Docket No. 50-245

Safety Assessment Report

Millstone Nuclear Power Station, Unit No. 1
SEP Safety Assessment Report

Topic 11-1.A - Exclusion Area Authority and Control

THE MILLSTONE POINT CO.
 FIGURE 2.2.1-6 SITE LAYOUT &
 METEOROLOGICAL TOWER LOC.

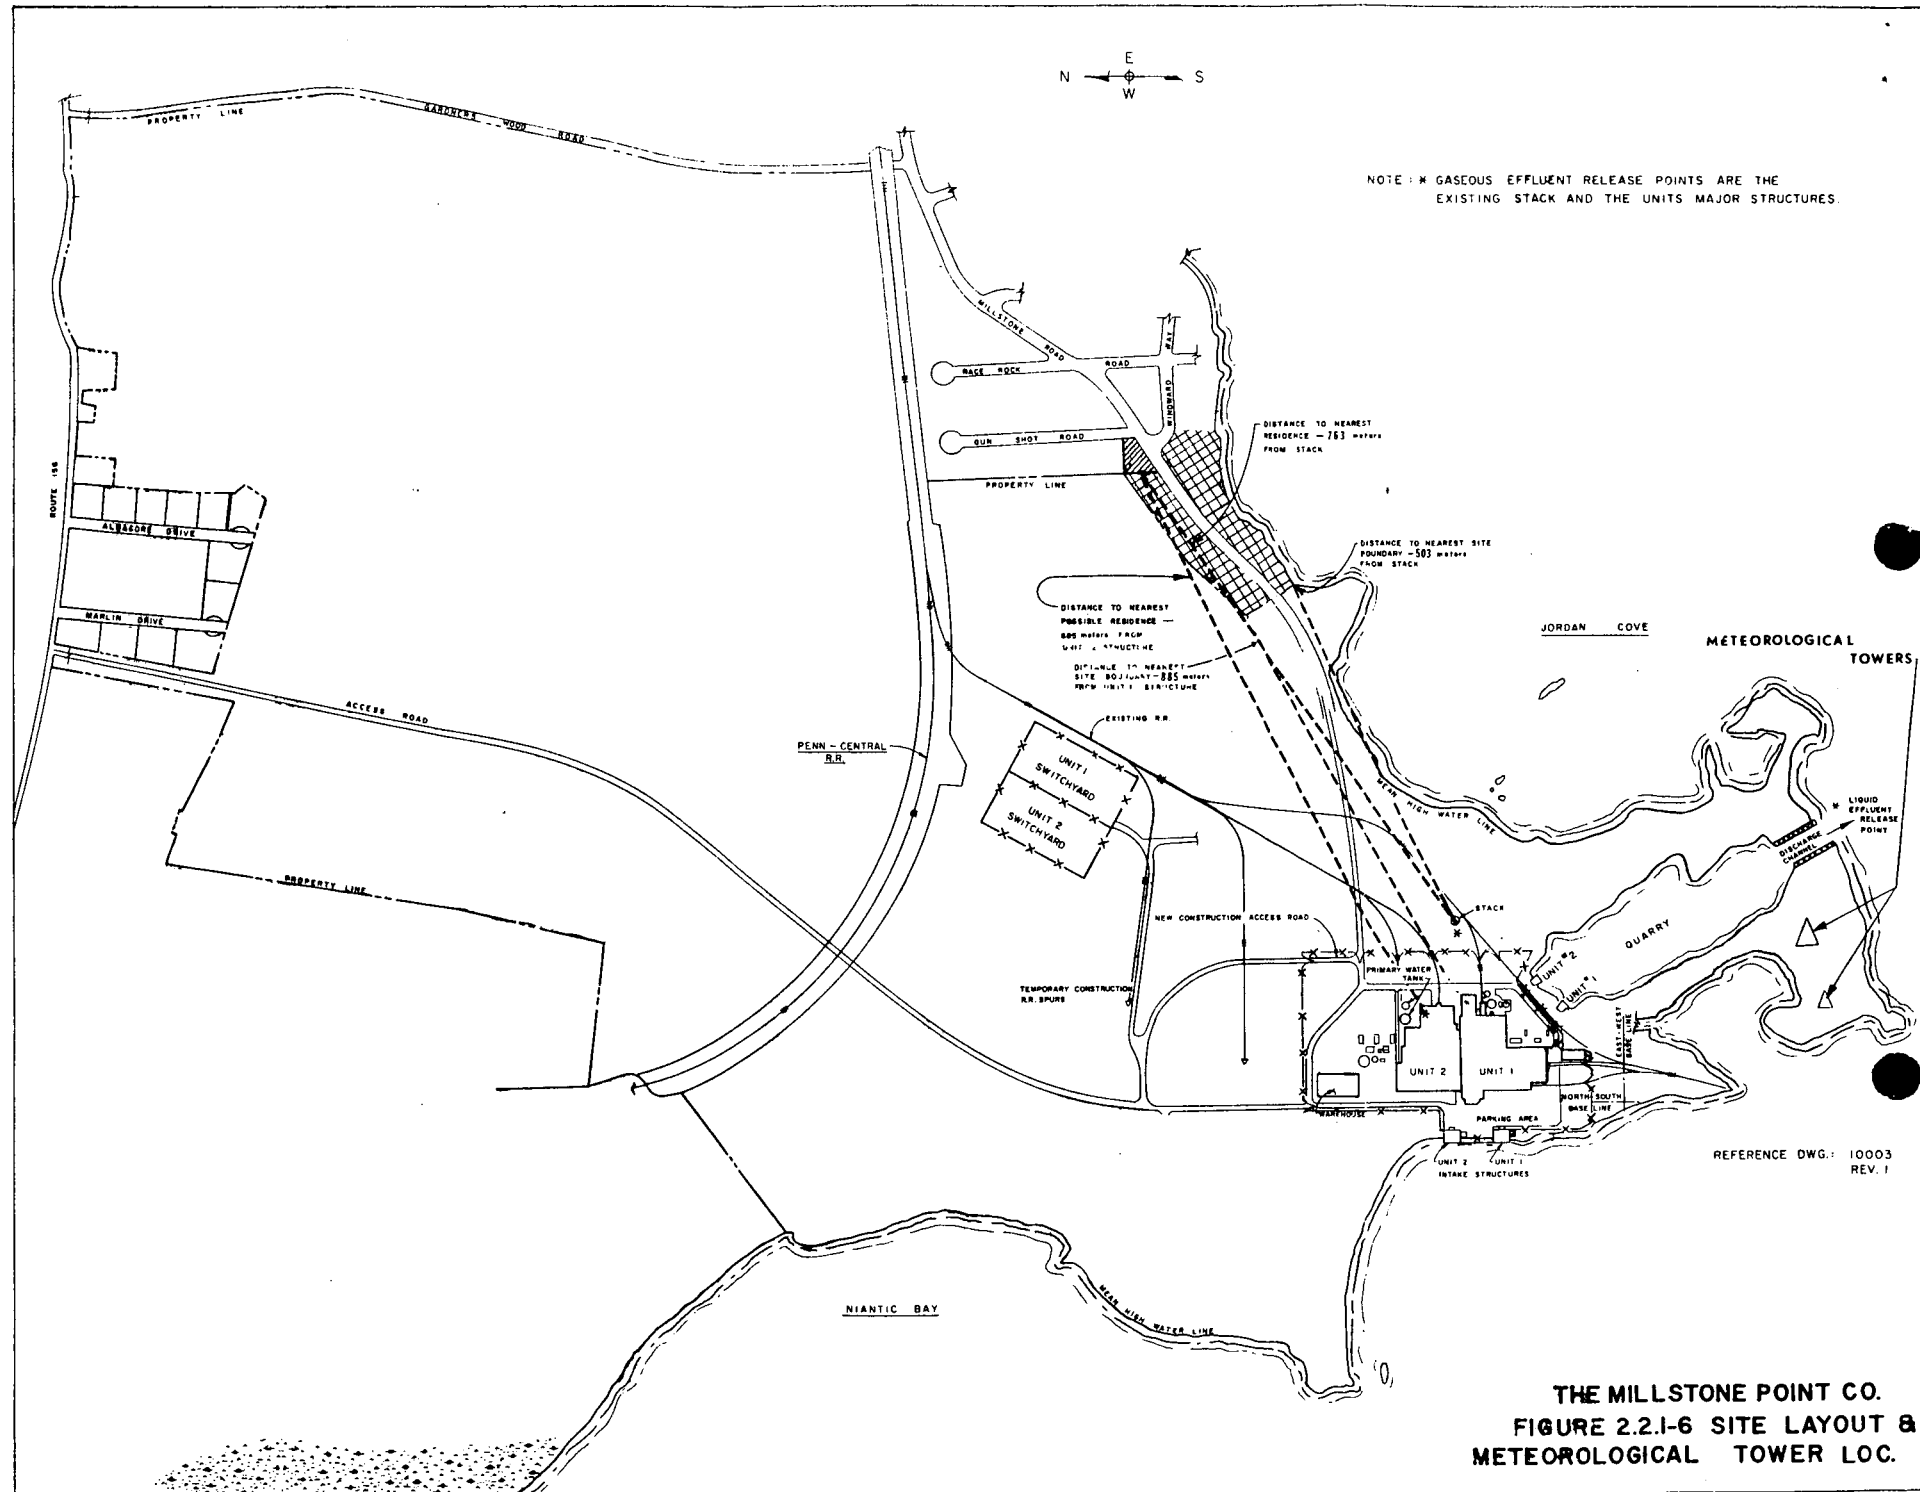
Millstone Unit No. 1 is located in the town of Waterford in New London county, Connecticut, on the north shore of Long Island Sound. The 500 acre Millstone site is 3.2 miles west-southwest of New London town limits and 40 miles southeast of Hartford, Connecticut. The exclusion area, which is defined as the area within the site boundary, is wholly owned by the Licensees, who have complete control of activities including mineral rights within the exclusion area except for the passage of trains along the

Penn Central railroad track which runs east-west through the site. Provisions have been made with Amtrak, as described in the Millstone Nuclear Power Station Emergency Plan, to divert train traffic away from the Millstone site and to enforce traffic control, should the need arise. No public highways traverse the exclusion area. The site is shown in Figure 2.2.1-6 of the Millstone Unit No. 1 FSAR, which is included as Figure 1. The distance from the Unit 1 stack to the nearest exclusion area boundary on the landward side of the plant is 503 meters.

NNECO maintains an area within the exclusion area assigned as a wildlife preserve as well as swimming and fishing areas. The recreational areas, however, have been closed due to the construction activities at Millstone Unit No. 3.
